Docket Items # 6 & # 7
BAR CASE # 2017-00145 &
2017-00146

BAR Meeting
June 7, 2017

ISSUE: Partial Demolition/Capsulation and Alterations

LOCATION: 1605 King Street

LIGHT RAIL TYPE 1 | TYPE 2 | TYPE 3

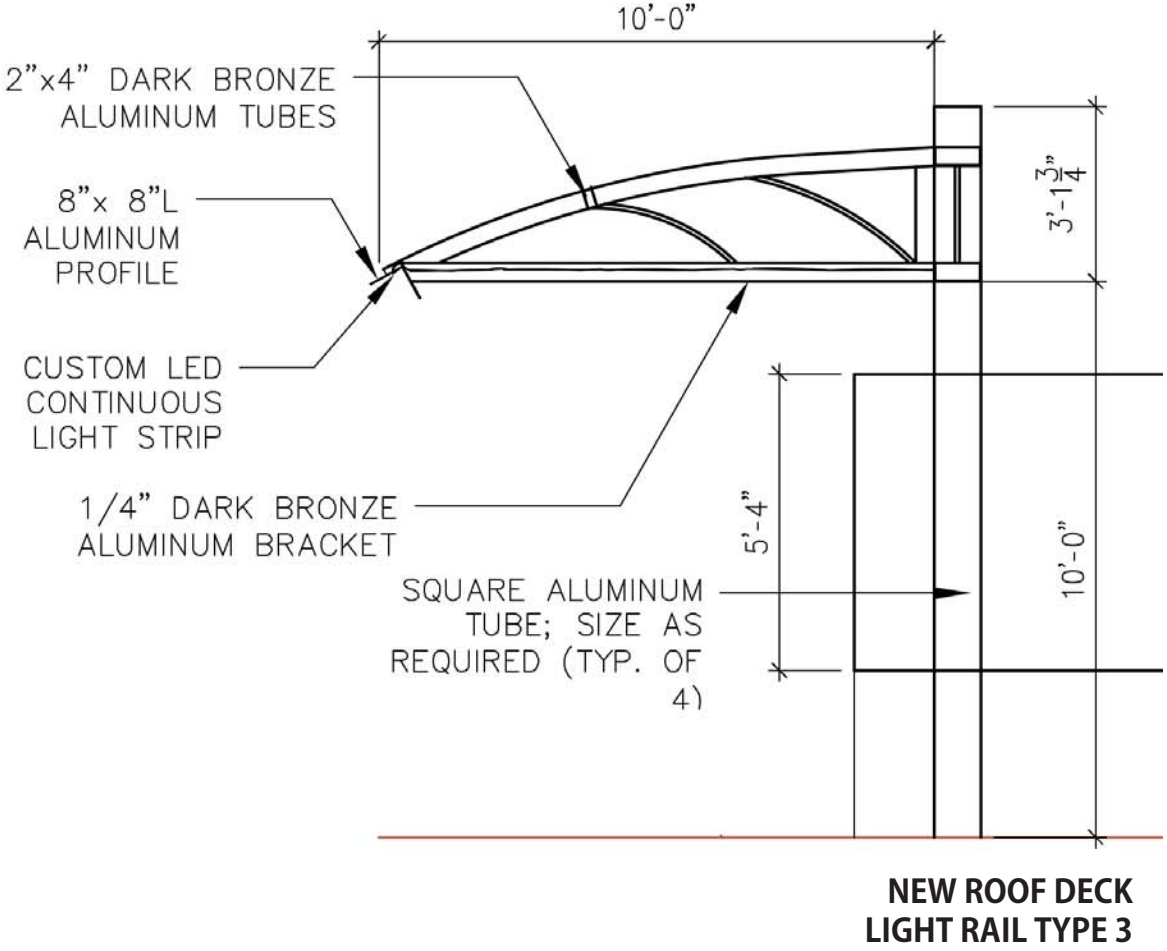
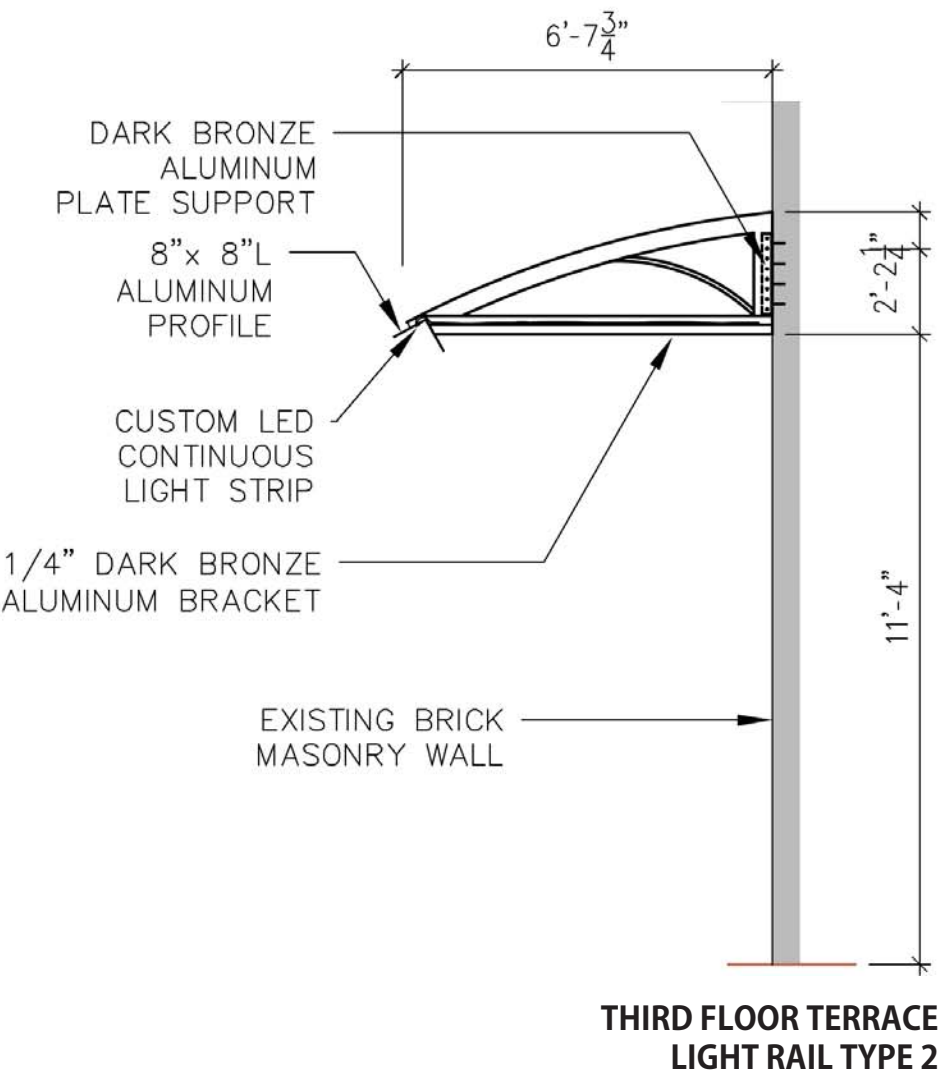
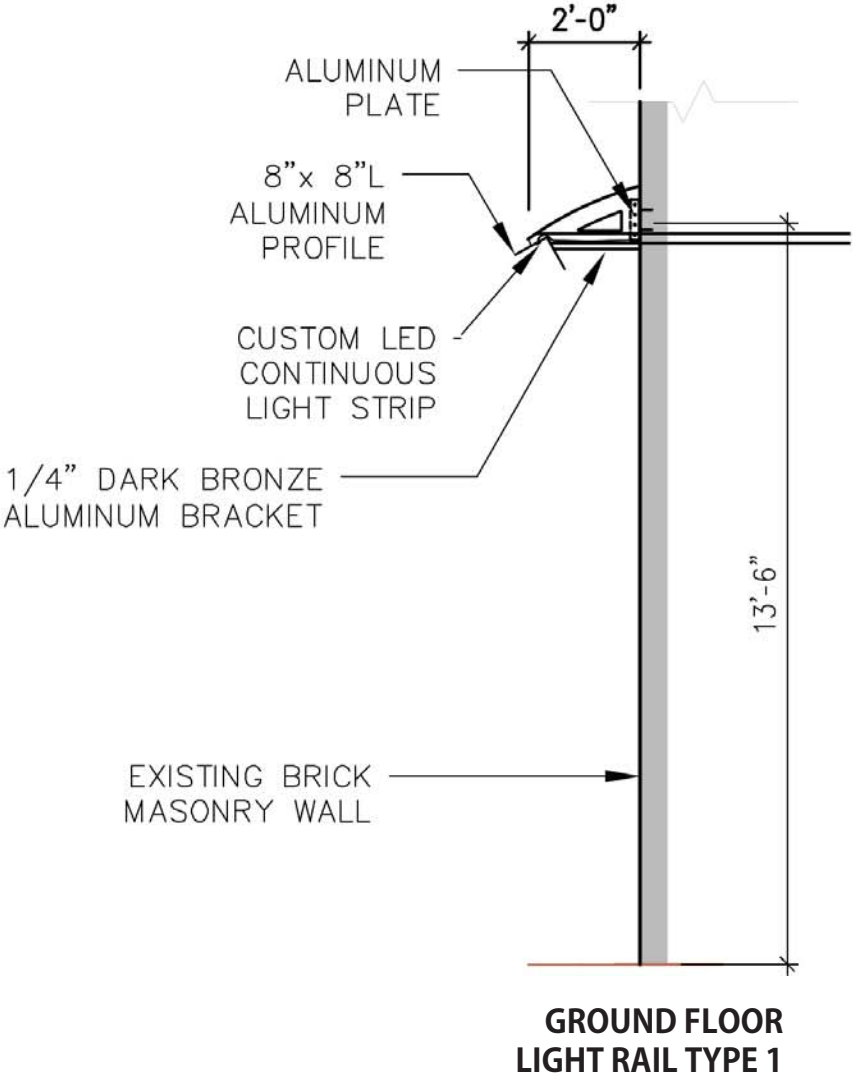
- C-3 Proposed roof terrace complies with zoning.
- C-4 Proposed Light Rail Type 1 and 2, and new entry canopy projections comply with zoning and section 5-2-29 for street encroachments of the Code of Ordinances.

- C-5 Proposed Light Rail Type 3 appears to increase the building height beyond the zone maximum height threshold of 50 feet. Please call out height from the average finished grade on all proposed elevations to show compliance with the 50 foot height maximum.

COMPREHENSIVE SIGNAGE SCHEDULE

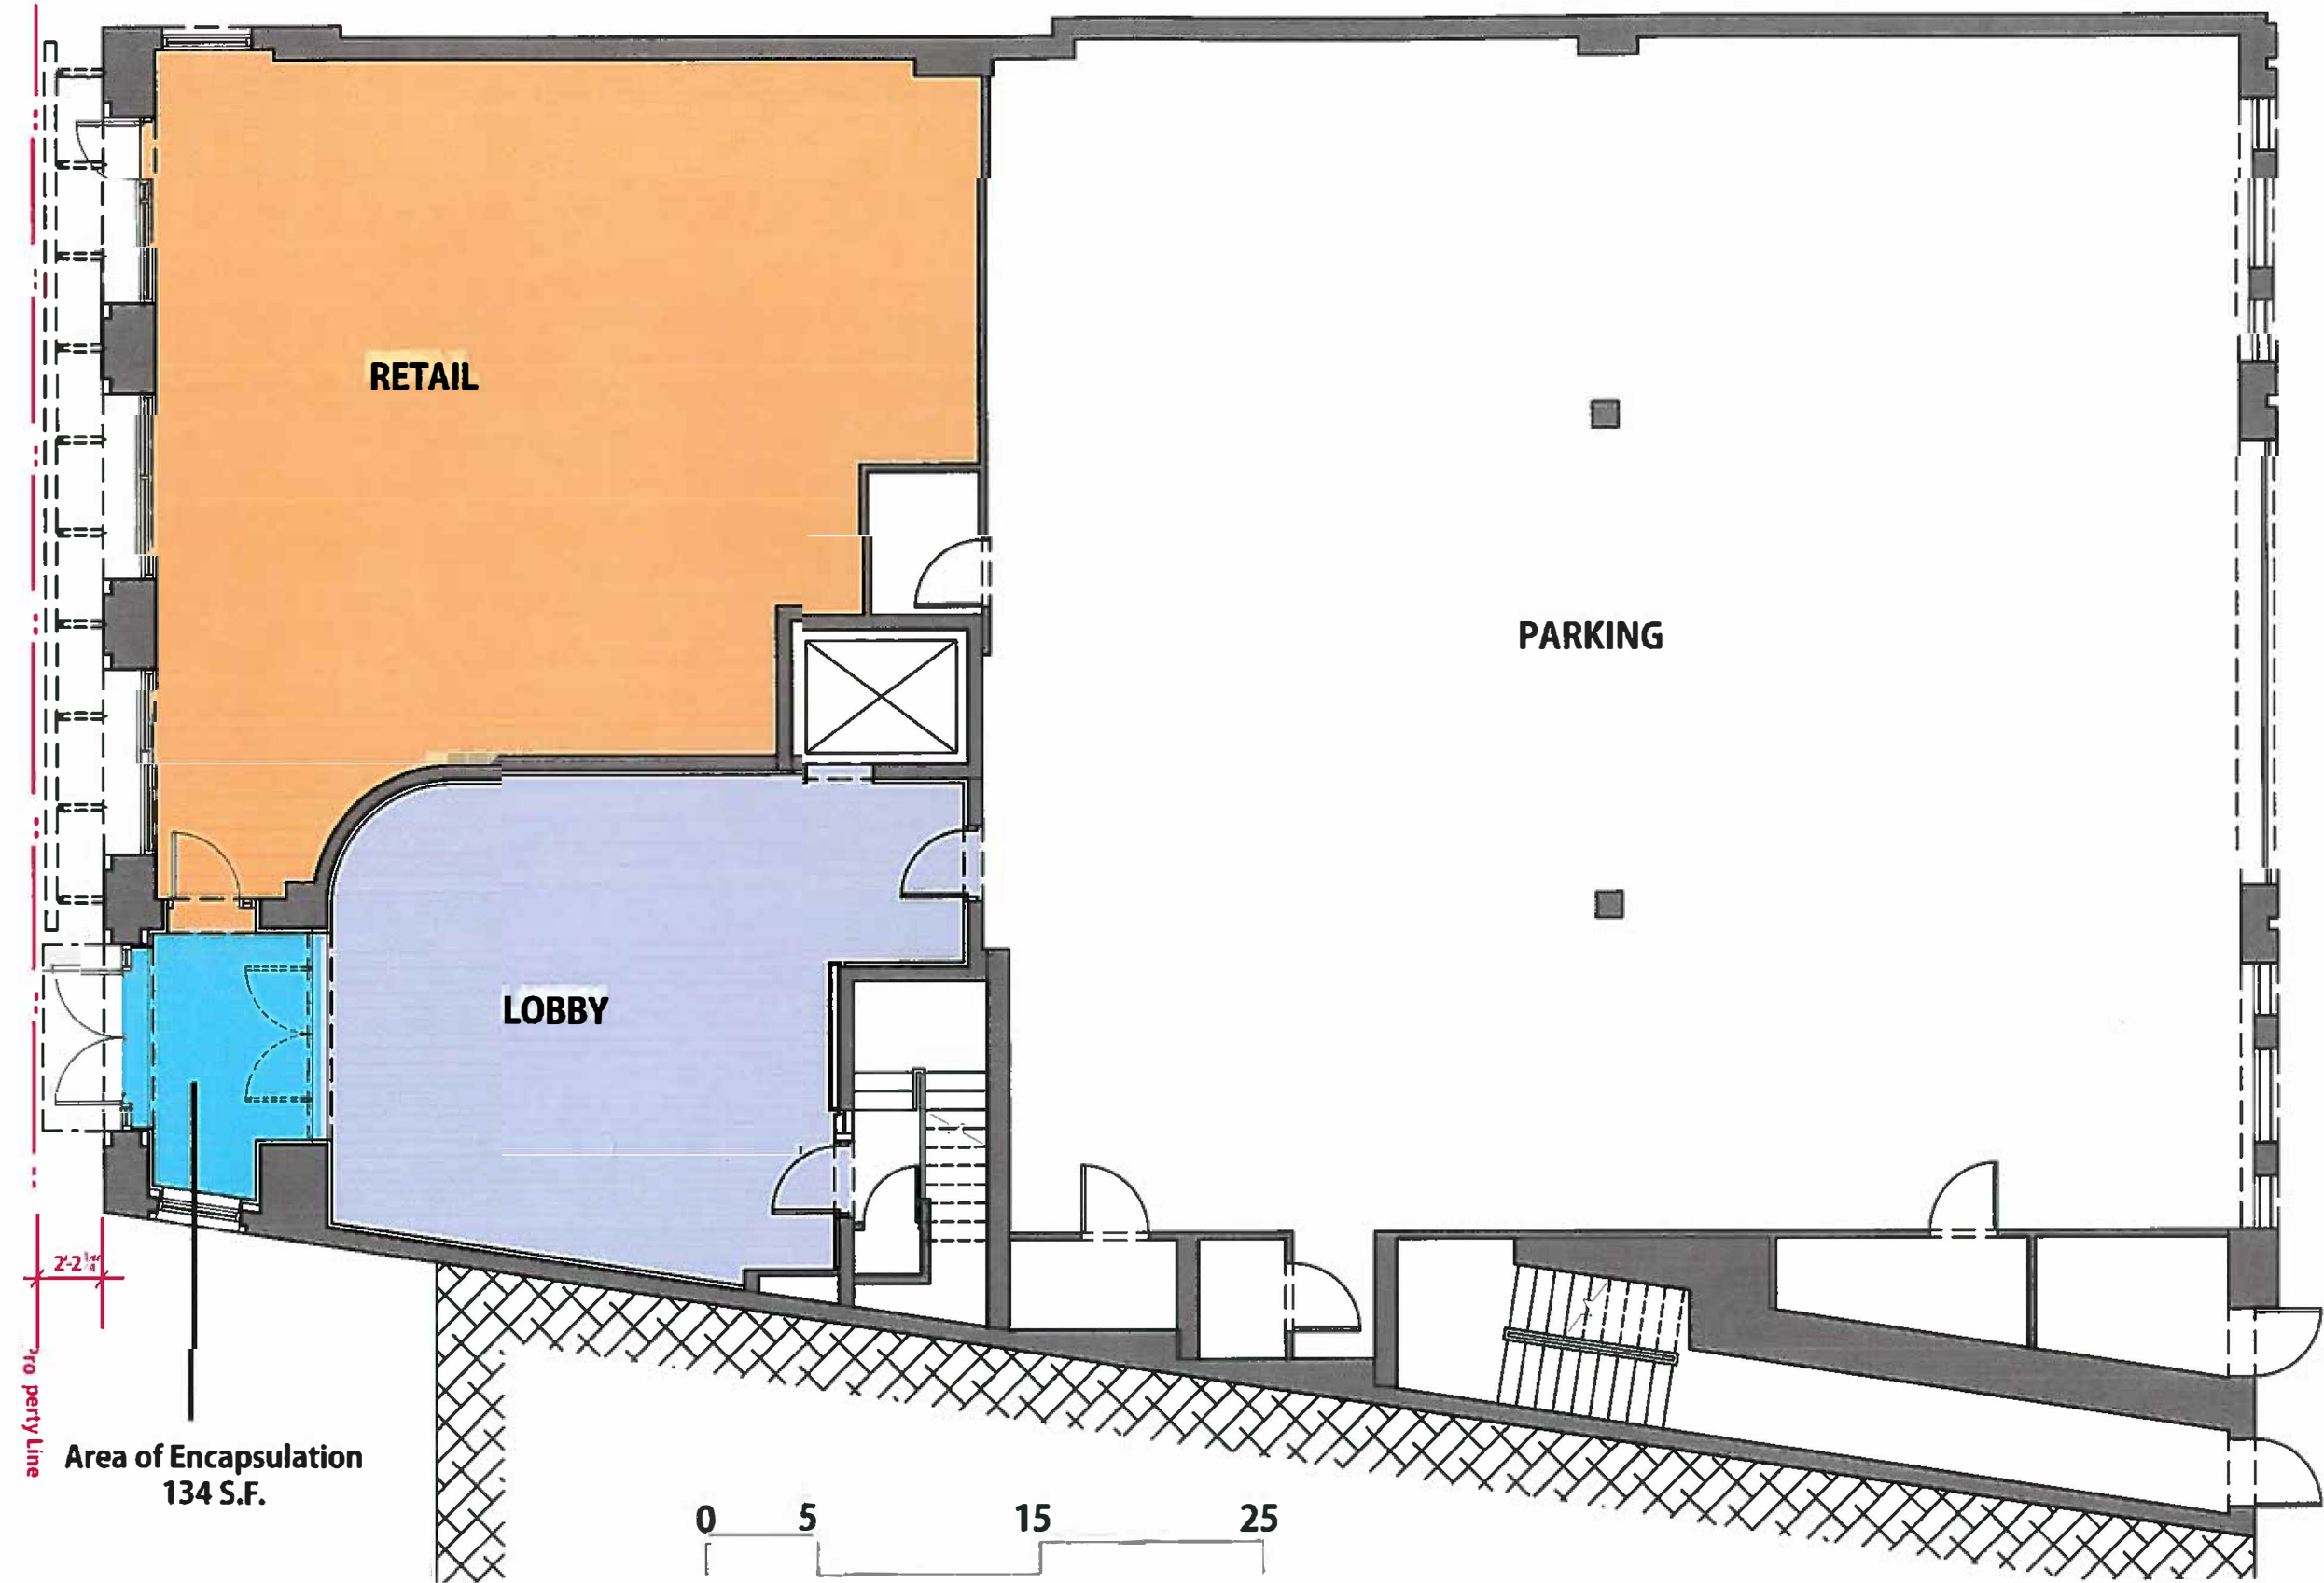
1. No internal illumination of signage is permitted. Halo illumination or targeted mini-spotlights for the two wall signs and hanging sign may be approved by staff as part of the sign permitting process.
2. No pin-mounted letters may be installed through the brick. Should the BAR approve pin-mounted letters, installation specifications showing the use of a silicone adhesive or shop drawings showing the installation location of all letters in the mortar joints must be approved by staff as part of the sign building permit process.

The applicant's sign package suggests internally illuminated letters for the wall signs. The sign illumination policy direction from the BAR, provided during consideration of new signs for several Burke & Herbert Bank buildings several years ago, is that internally illuminated box signs or individual can letters are not appropriate in the historic district but that halo illuminated can letters may be appropriate on modern buildings. The BAR stated that only externally illuminated signs are appropriate on historic buildings. Therefore, staff recommends that the only lighting permitted be halo illumination or targeted mini spotlights, to be approved by staff as part of the sign permitting process.

Additionally, the BAR's policy is to discourage pin-mounted individual letters mounted directly into the brick because they cause permanent damage to the bricks, whether historic or modern. However, one applicant recently applied pin-mounted letters with a silicone adhesive which was represented to be reversible and staff believes *may* be an appropriate solution. Alternately, if an applicant can provide a scaled and detailed sign plan and shop drawings showing the exact installation of each individual letter through the mortar joints, staff can support the individual pin mounted letters.

- C-6 Proposed Signage and Flags including Sign A, Sign B, Sign C, Sign D, Sign E, and Sign F and Flags 1-3 comply with zoning. Sign E must also adhere to section 5-2-29 for street encroachments of the Code of Ordinances. Sign F must be located 35 feet below grade to comply with Section 9-104(B)(10).
